# PHILCO TV

## SCHEMATIC DIAGRAMS

MODEL 48-700 THRU 53T2750

Figure 11. Addition of Astigmatic Control, Run 6

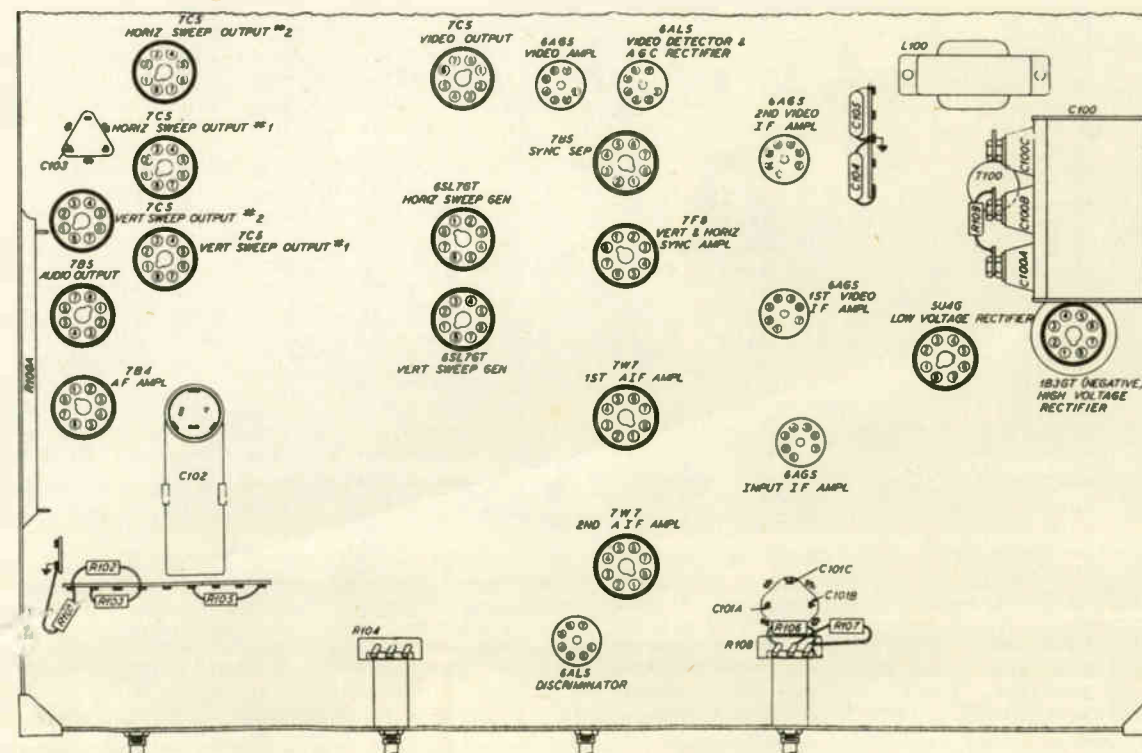
In sets prior to Run 6, the background control, R108, may fail because of transients or surges under certain operating conditions. When replacing this control, it is suggested that the circuit be rewired as shown in figure 11. This change was incorporated in production in Run 6.

Figure 3. New Discriminator Transformer and Associated Circuit

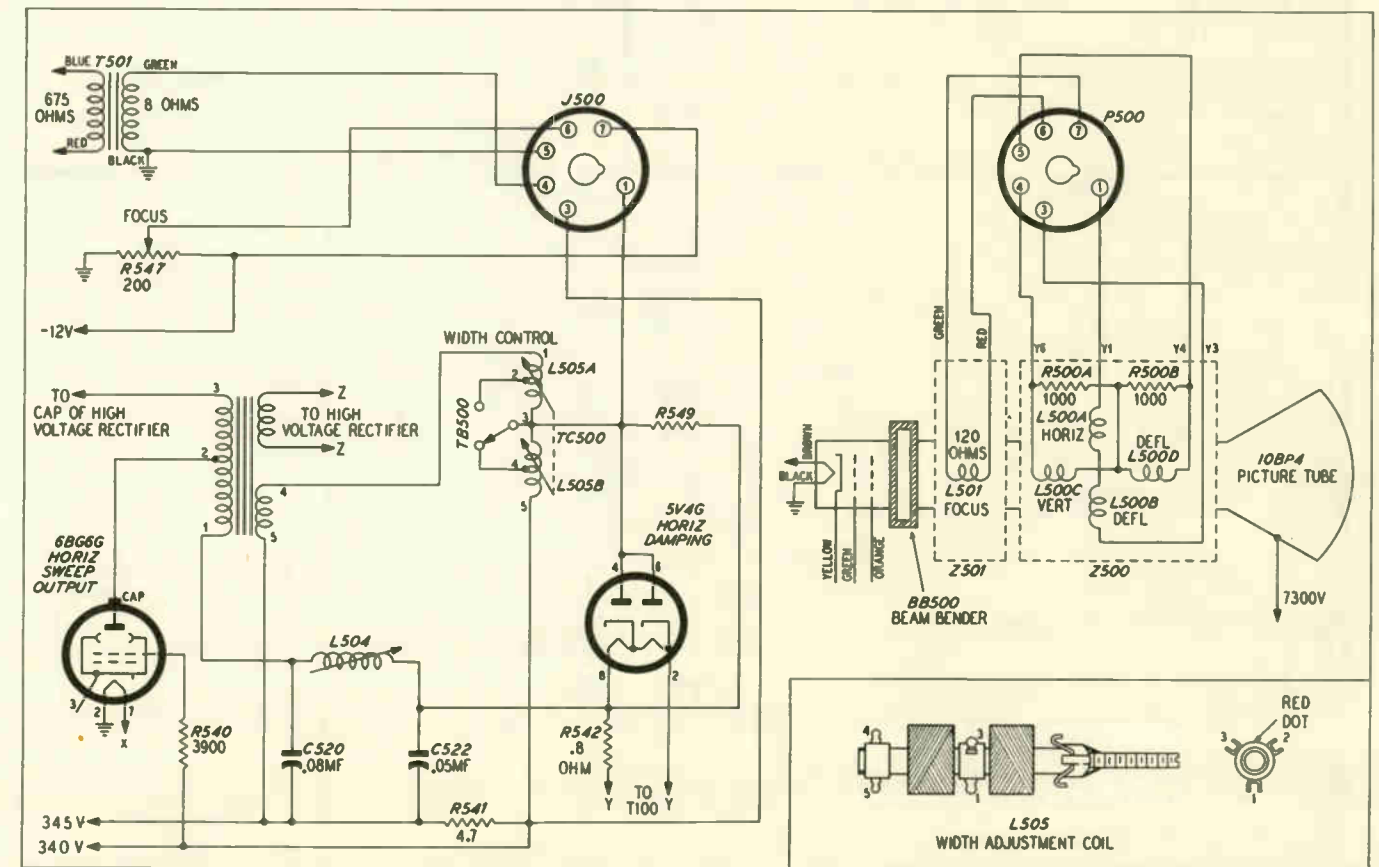
7. C202C, condenser, balancing, part of Z202, was removed.
8. C202B, 10 mmF., part of Z202, was changed to 20 mmF., and resymbolized C202A.
9. C206, .001 mf., Part of No. 45-3500-5\*, was removed from the cathode (pin 7) of the 2nd a-i-f tube, and connected as shown in figure 3.

10. R222, 47,000 ohms, Part No. 66-3473340\*, was added. See figure 3.
11. R223, 47 ohms, Part No. 66-0473340\*, was added. See figure 3.
12. R219, 3300 ohms, Part No. 66-2333340, was changed to 1200 ohms, Part No. 66-2123340.

Figure 4. Changes in Output Circuit

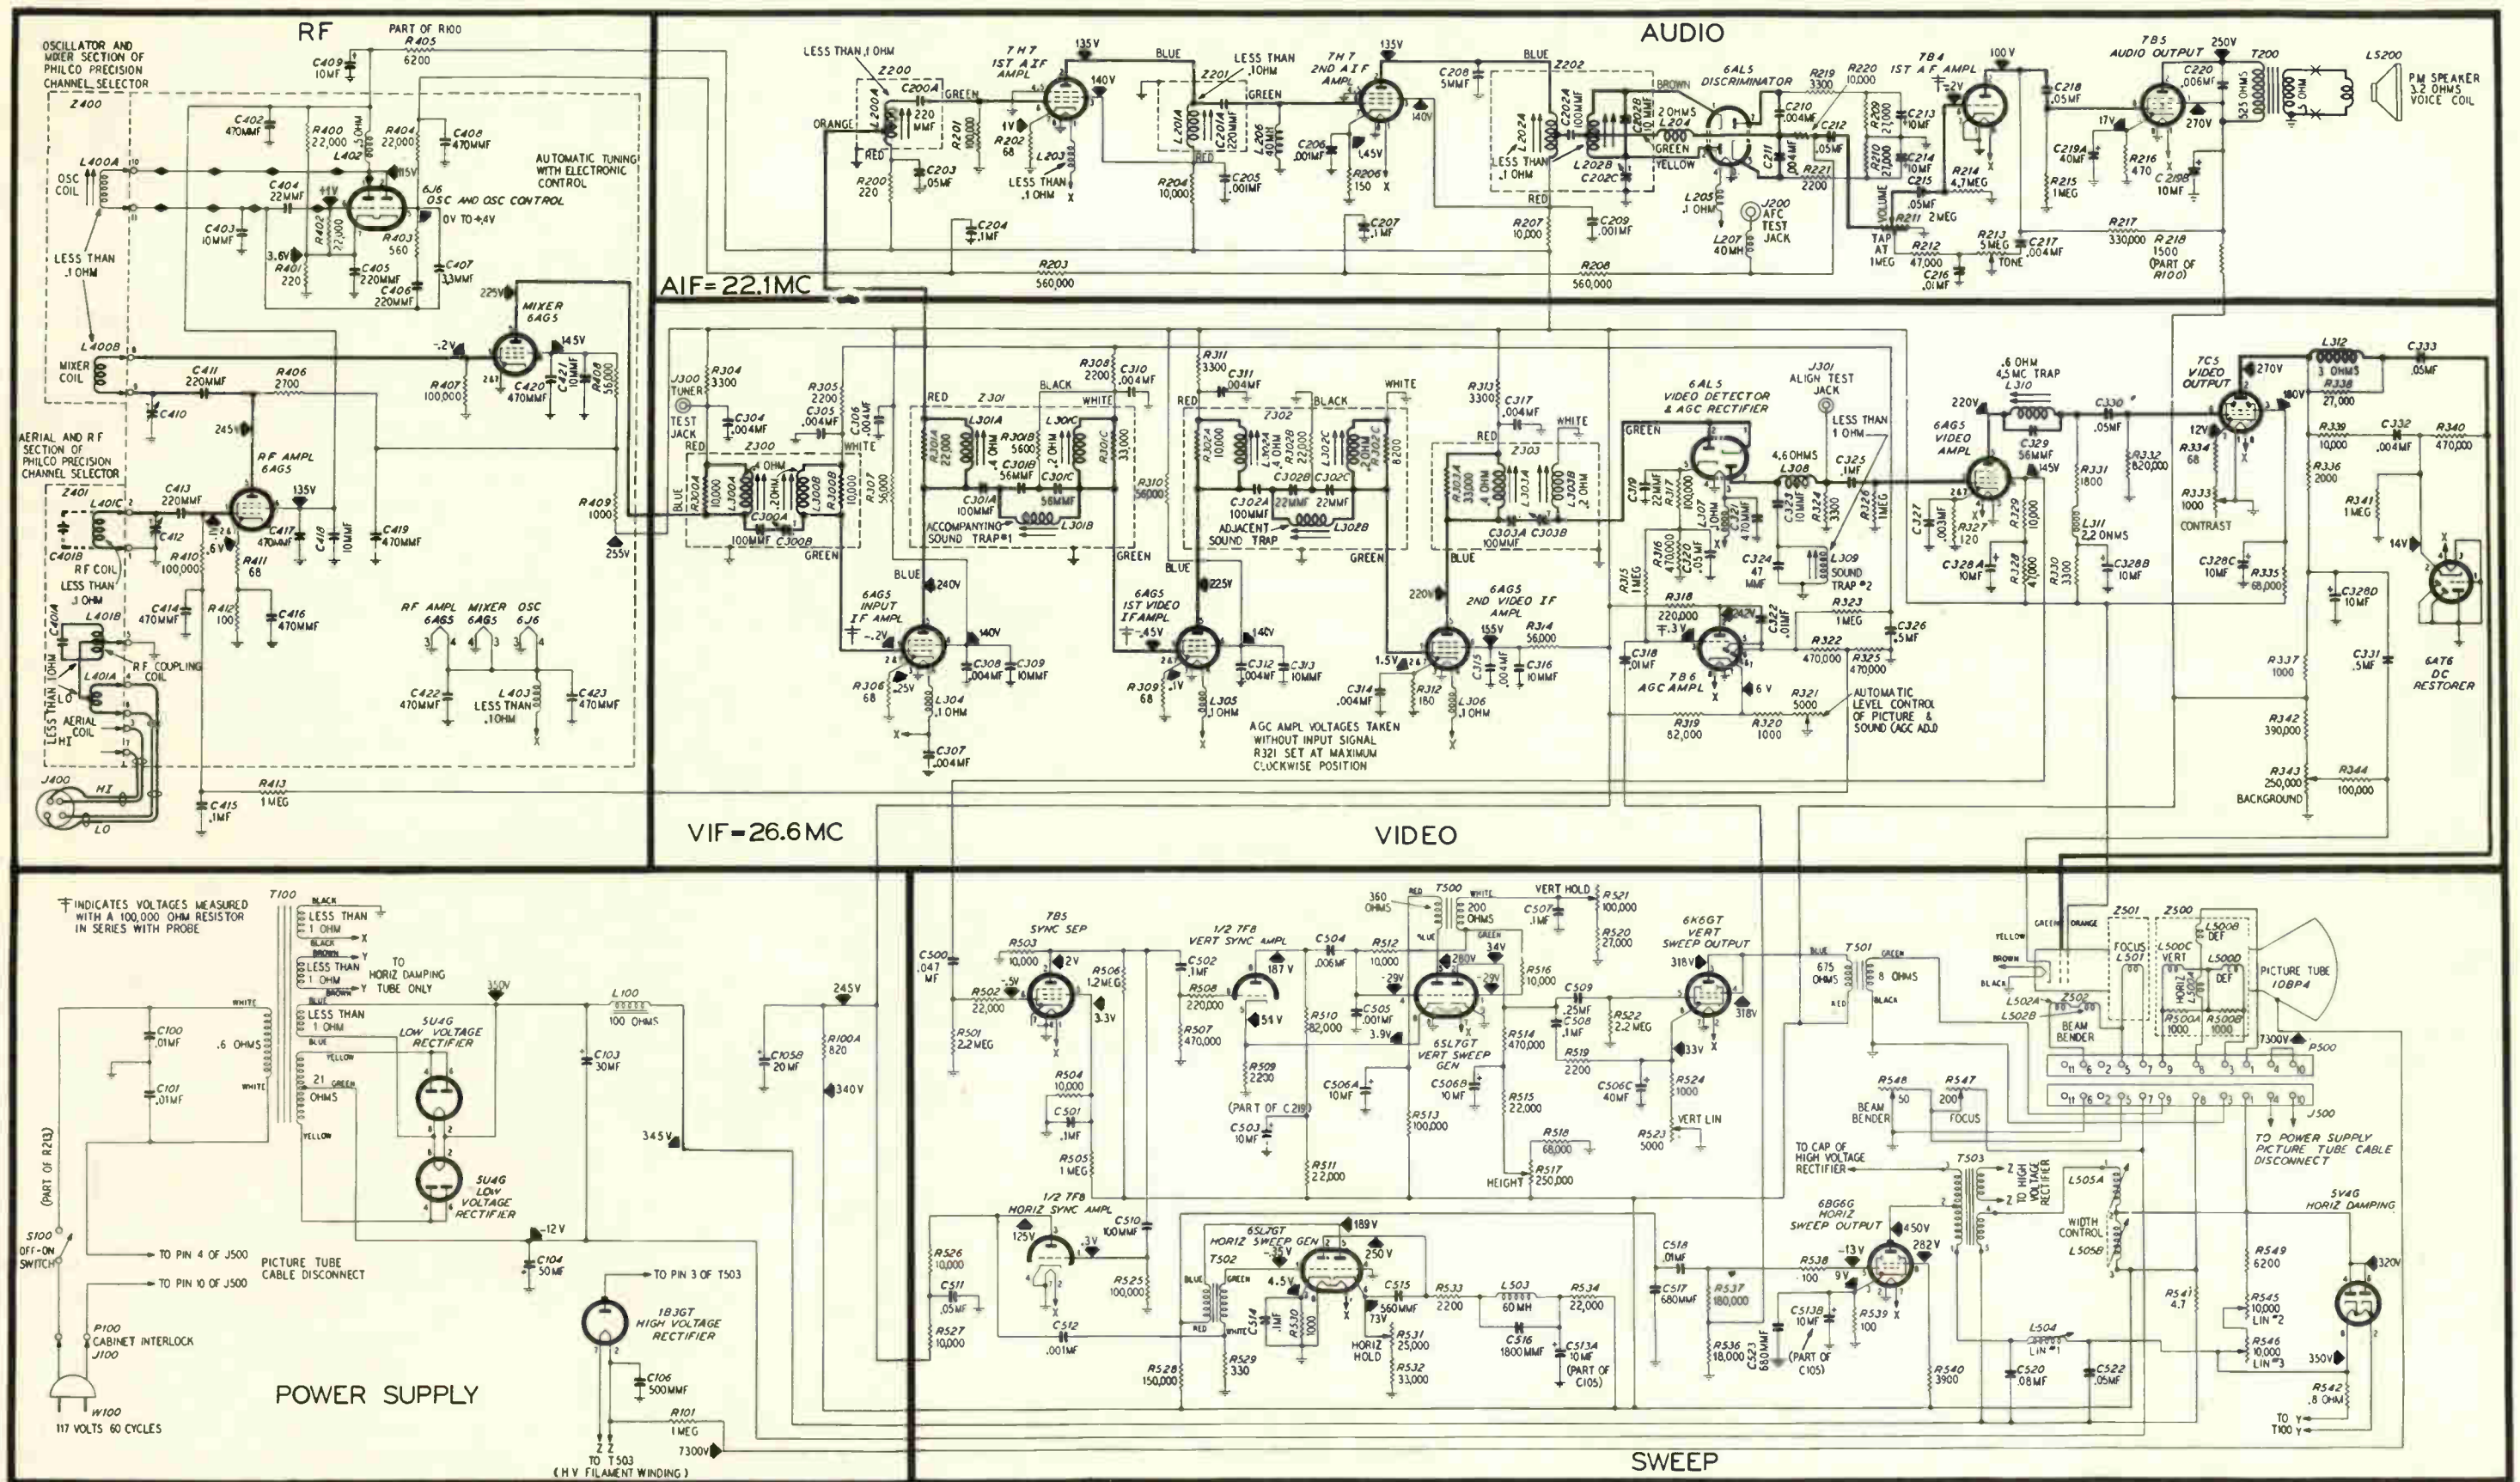
#### Section 5 (see figure 4)

1. C509, condenser, coupling, .25 mf., Part No. 61-0125\*, was changed to .1 mf., Part No. 61-0113\*.
2. The connection of the vertical deflection yoke, P9 and P3, were changed to 4 and 5, respectively.
3. R549, resistor, linearity-control limiting, 6200 ohms, was changed to 33,000 ohms, Part No. 66-3333340\*.
4. R545 and R546, horizontal linearity controls No. 2 and No. 3 were removed. The circuit was rewired as shown in figure 4.
5. R548, beam-bender control, was removed.
6. Z502, beam-bender-coil assembly (including L502A and L502B) was removed.
7. A permanent-magnet type of beam bender (BB500), Part No. 76-3913, was added.
8. J500, receptacle, chassis (deflection-yoke-cable connector) 11 pins, Part No. 27-6229, was changed to 8 pins, Part No. 27-6174-4.
9. P500, deflection-yoke-plug connector and cable, 11 pins, Part No. 41-3764-1, was changed to 8 pins, Part No. 41-3860.

Figure 22. Changes in Horizontal-Sweep-Generator Circuit, Code 121, Run 3

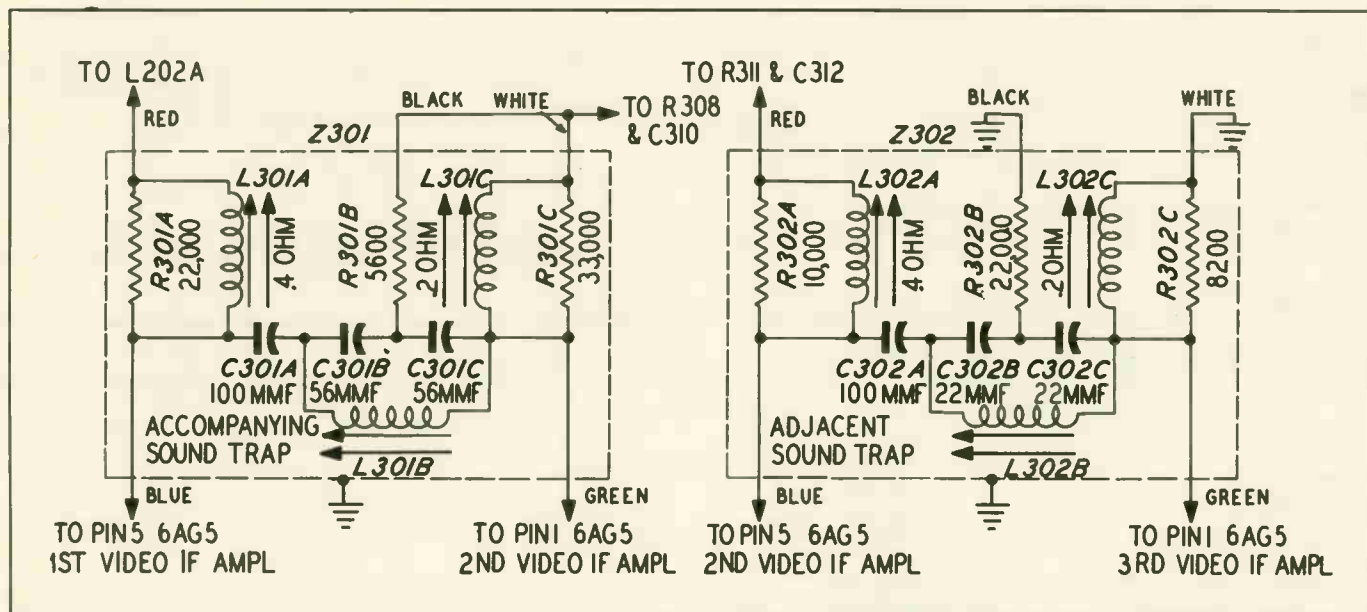
3. R531, 560,000 ohms, Part No. 66-4564340\*, was changed to 33,000 ohms, Part No. 66-3333340\*, and connected as shown in figure 22.

4. R532, 250,000 ohms, Part No. 33-5539-13, was changed to 25,000 ohms, Part No. 33-5539-28, and connected as shown in figure 22.
5. R533, 220,000 ohms, Part No. 66-4224340\*, was changed to 22,000 ohms, Part No. 66-3223340\*, and connected as shown in figure 22.

8. R551, 1000 ohms, Part No. 66-2103340\*, was added, as shown in figure 22.
9. R552, 2200 ohms, Part No. 66-2223340\*, was added, as shown in figure 22.

10. C513A, 10 mf., was connected as shown in figure 22.
11. C514, 820 mmf., Part No. 60-10825401\*, was changed to .1 mf., Part No. 61-0113\*, and connected as shown in figure 22.

12. C515, 820 mmf., Part No. 60-10825401\*, was changed to 680 mmf.,  $\pm 5\%$ , Part No. 60-10685401\*, and connected as shown in figure 22.
13. C516, .01 mf., was connected as shown in figure 22.

14. C523, 200 mmf., Part No. 60-20205304\*, was added, as shown in figure 22.
15. C524, 560 mmf., Part No. 66-10565314\*, was added, as shown in figure 22.

16. L504, 60-mh., r-f choke, Part No. 32-4284, was added, as shown in figure 22.
17. A four-terminal wiring panel, Part No. 12W-45661, was added, between the vertical-sweep-output socket (6V6GT) and C506, on the bottom of the chassis.

Figure 21. Schematic Diagram of First and Second Video I-F Transformers, Z301 and Z302

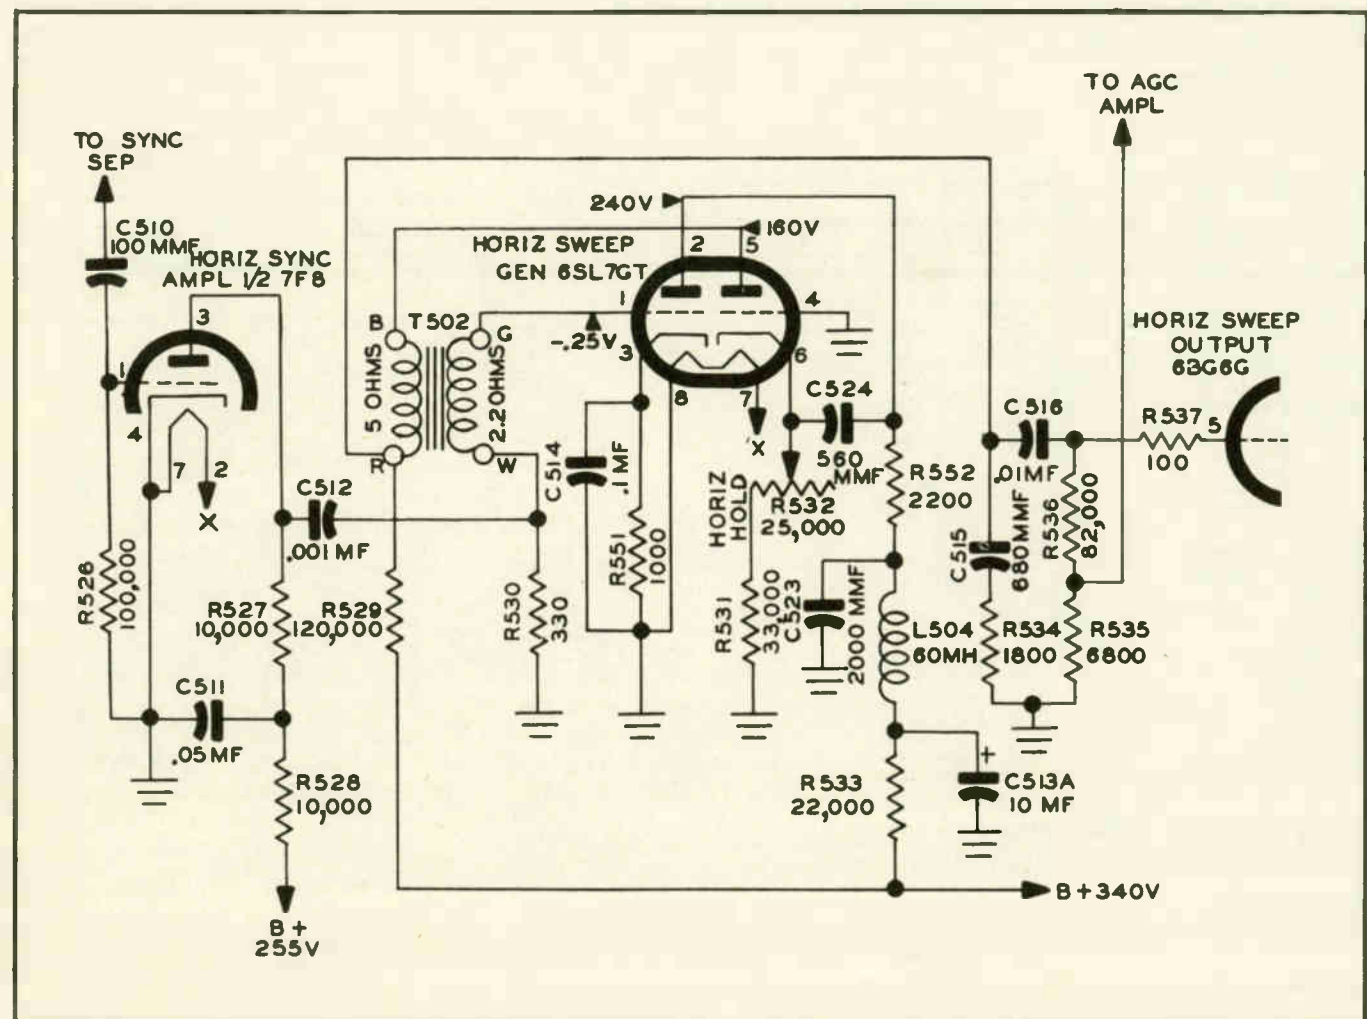
The new transformers are interchangeable with the corresponding originals. Only the new transformers are supplied for replacement purposes. Schematic diagrams of the two transformers are shown in figure 21.

Figure 1. Change in Horizontal-Output Circuit, Models 50-T1403, 50-T1404, and 50-T1406, All Code 125

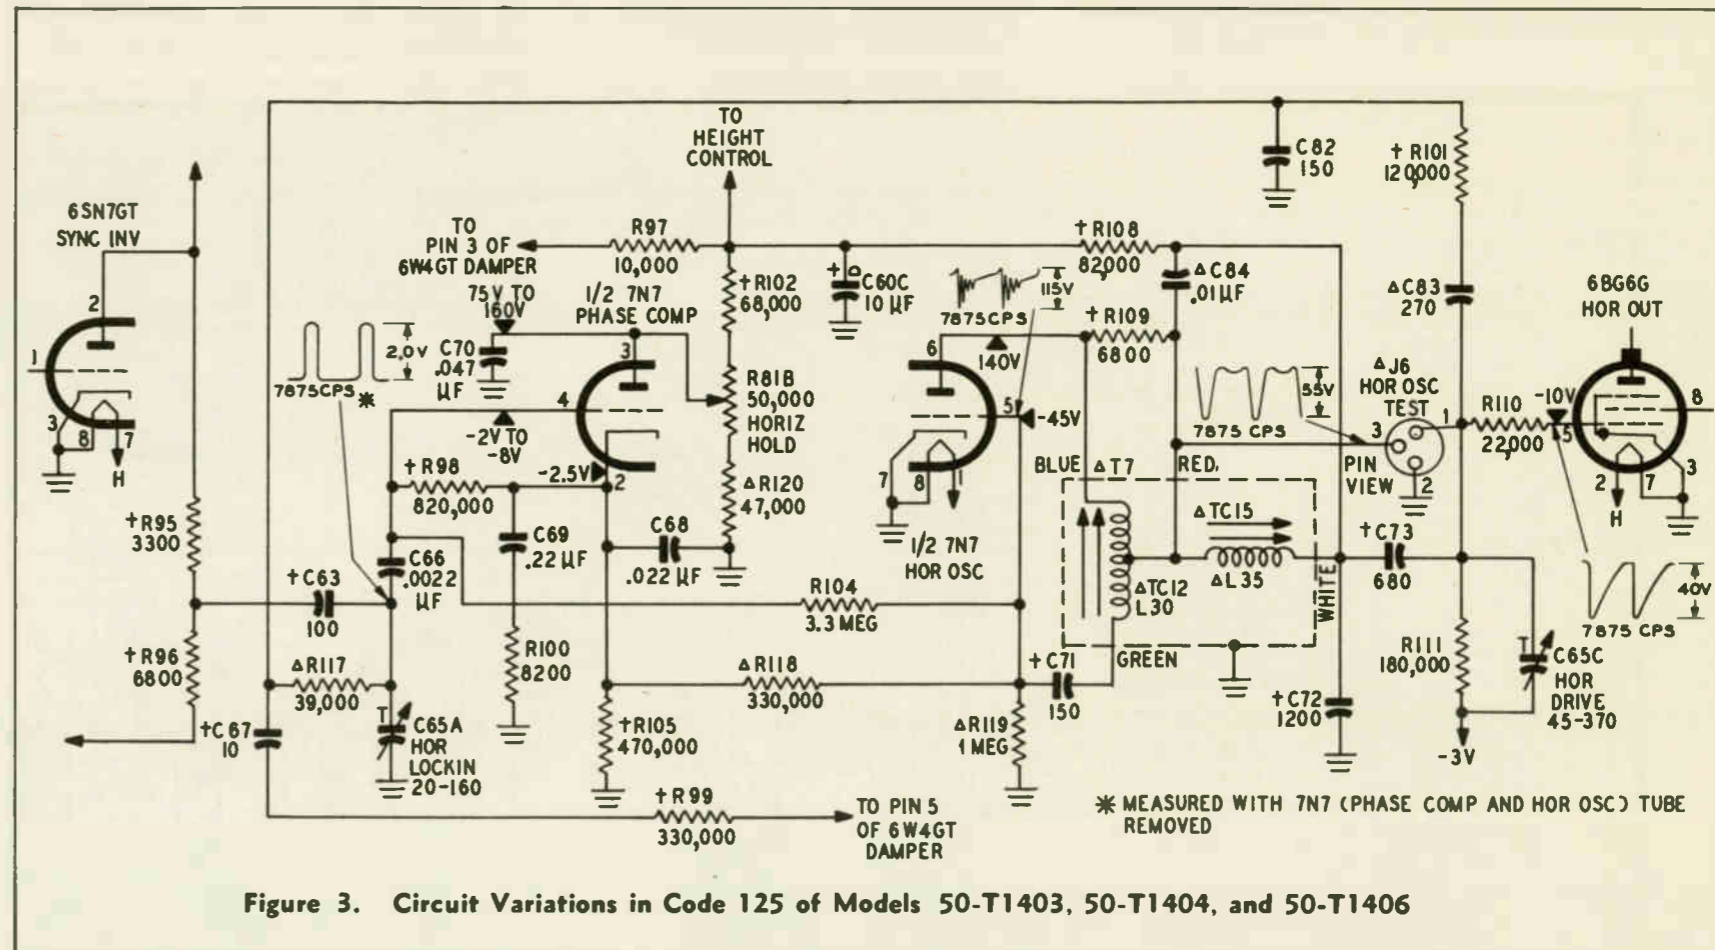
1. Resistor R118 was changed to 390,000 ohms, Part No. 66-4394240\*.
2. Condenser C83 was changed to .001  $\mu\text{f.}$ , Part No. 45-3505-52.
3. The blocking condenser (C71) in the horizontal-output circuit was rewired as shown in figure 1.
